Crankshaft Position Sensor: Customer Interest
Engine - Hard Starting and Detonation

Subject: Shielding Sleeve for Reference Mark

Sensor to Correct Hard Starting and Detonation (Ping)
 Model 924S, 944, 944S, 944 Turbo
 Group

8703
 February 20, 1987

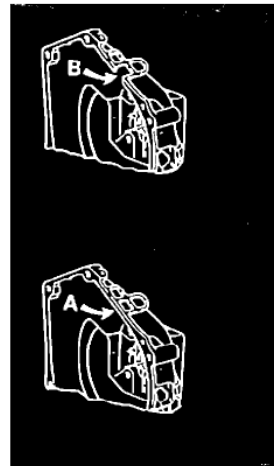
For Model '87 the opening in the clutch housing (Arrow B) for the speed and reference sensors is slotted. Because of this, it is possible that the reference mark sensor **may be inadequately shielded from magnetic interference from the starter during cranking.**

If detonation (pre-ignition) occurs during cranking and **starter operation is labored,** a reference sensor shielding sleeve and bracket should be installed.

It is planned to modify the clutch housing opening for the speed and reference sensors (Arrow A) for improved shielding effect. In the future, instead of slots will be used.

The reference sensor shielding sleeve is installed in production from VIN:

92 HN 453769	924S
94 HN 472809	944
94 HN 451857	944S
95 HN 151023	944 Turbo
